**Re: Daskalos Shopping Center
6000 San Mateo NE
Traffic Circulation Layout
Engineer's Stamp 7-16-25 (F18D039) TRANS-2025-00177**

DASKALOS SHOPPING CTR.
 6000 SAN MATEO BLVD NE,
 ALBUQUERQUE, NM 87109

TRAFFIC CIRCULATION LAYOUT

1 SITE PLAN
 SCALE: 1/16" = 1'-0"

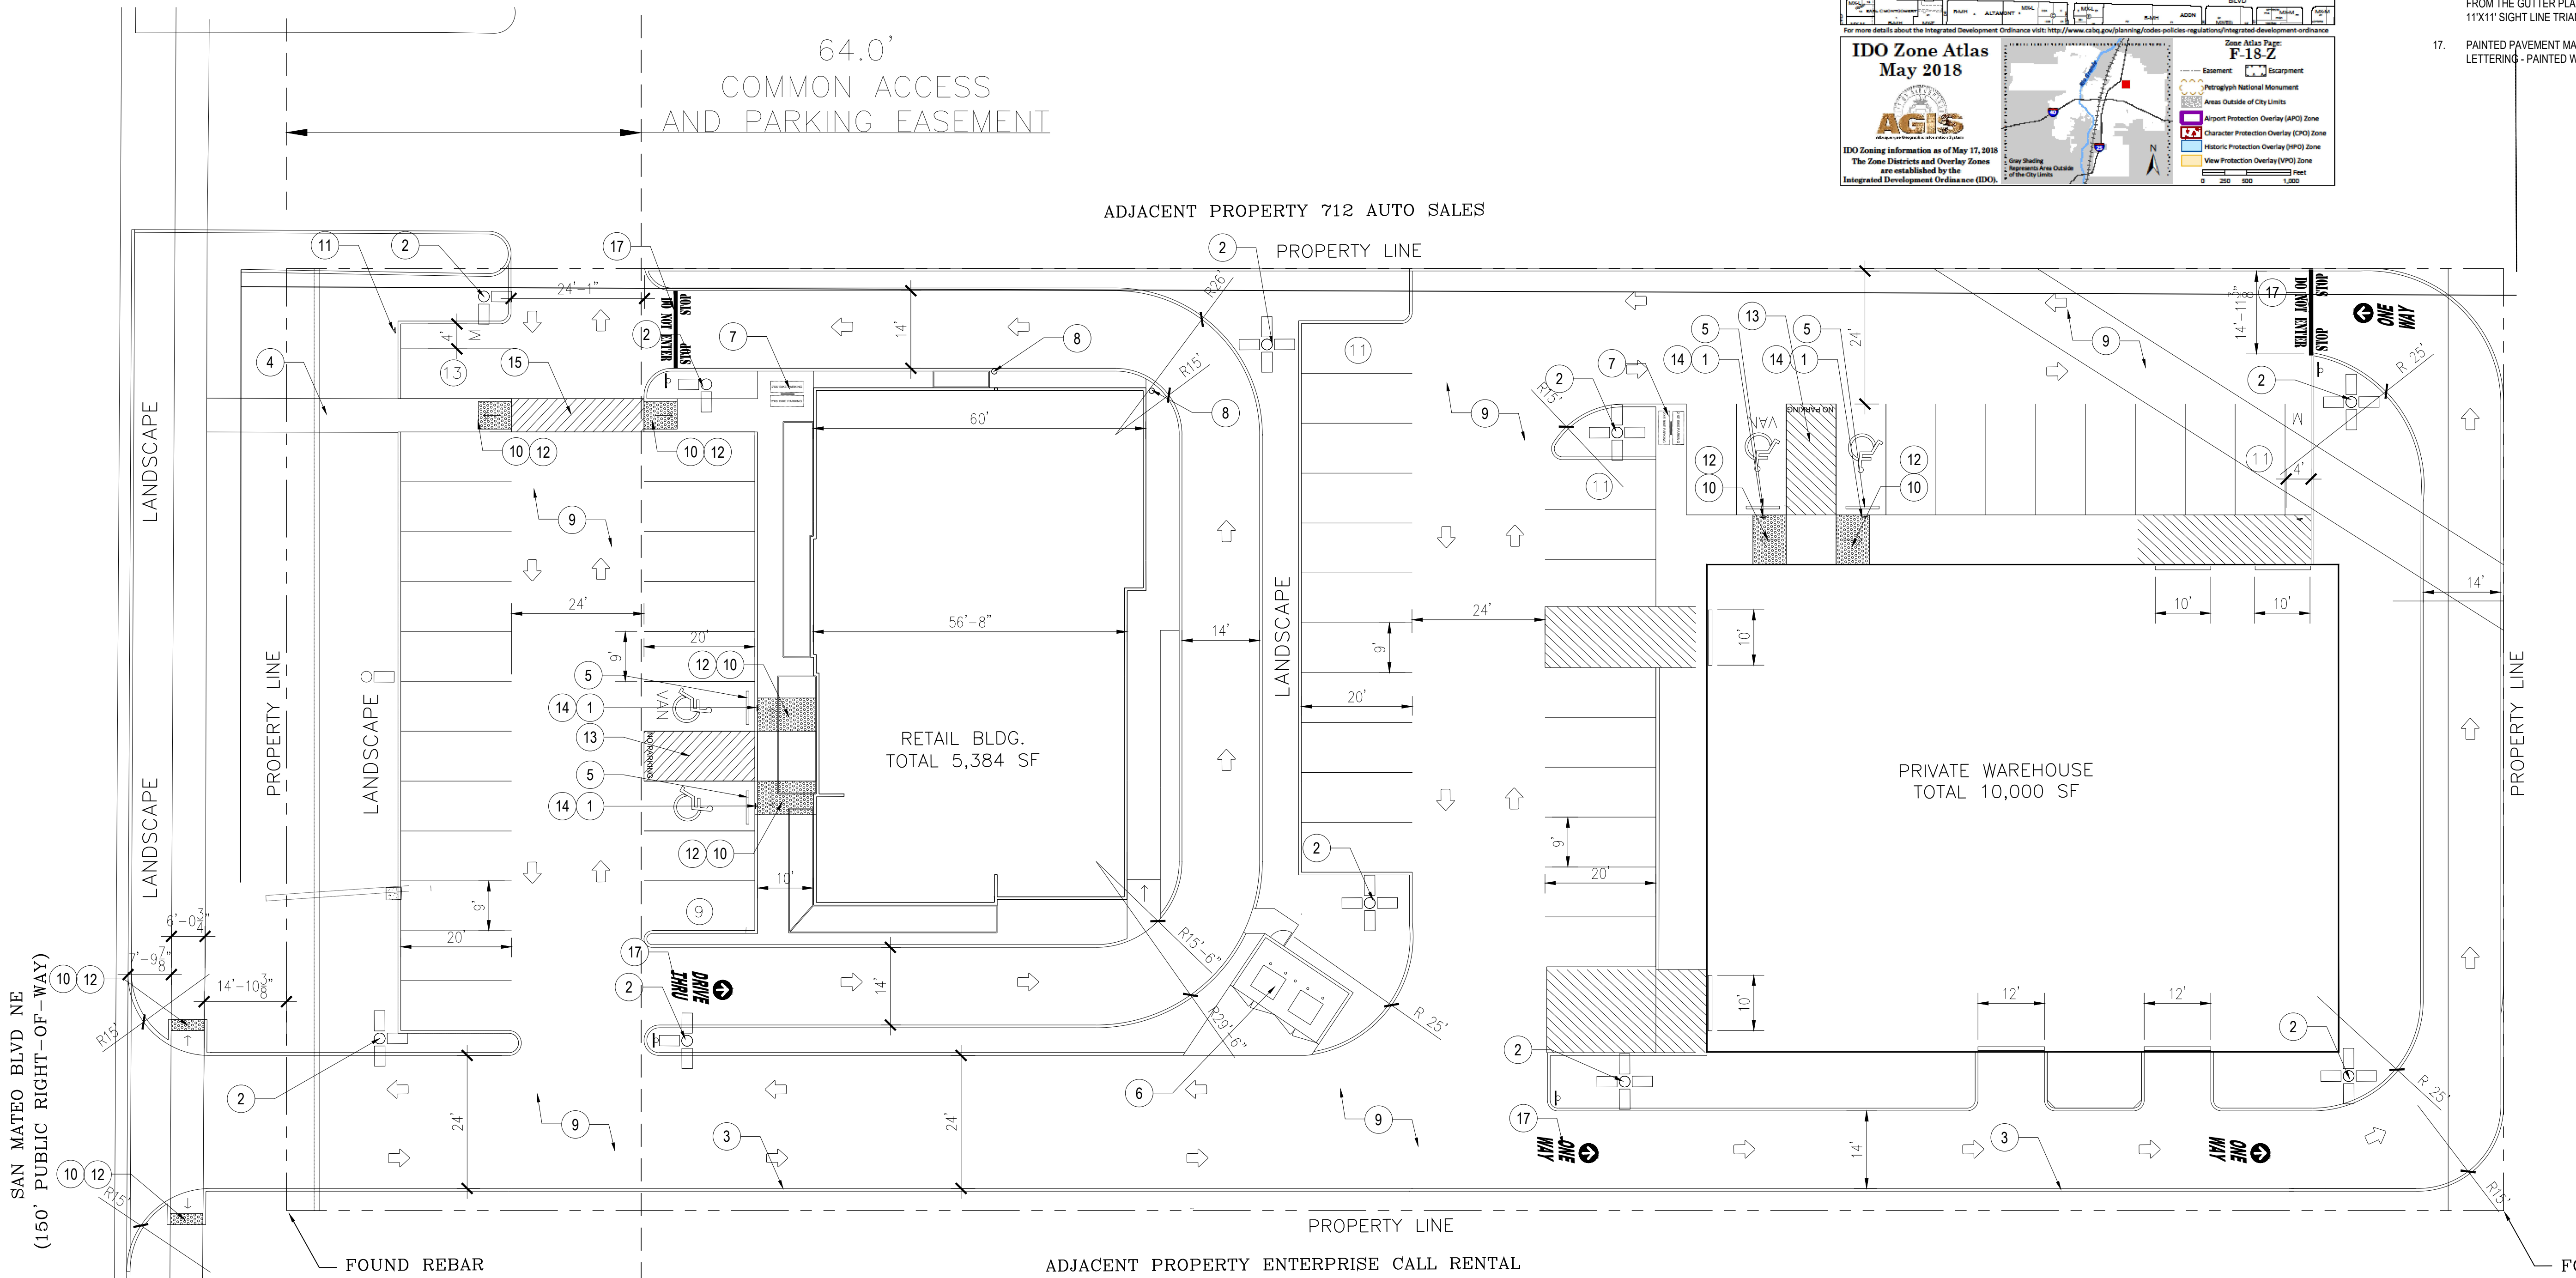
The TCL submittal received 7-7-25 is approved for Building Permit by Transportation. A copy of the stamped and signed plan will be needed for each of the building permit plans. Please keep the original to be used for certification of the site for final C.O. for Transportation.

When the site construction is completed and an inspection for Certificate of Occupancy (C.O.) is requested, use the original City stamped approved TCL for certification. Redline any minor changes and adjustments that were made in the field. A NM registered architect or engineer must stamp, sign, and date the certification TCL along with indicating that the development was built in "substantial compliance" with the TCL. Submit this certification, and the TCL to the [ABQ-PLAN](#) for log in and evaluation by Transportation.
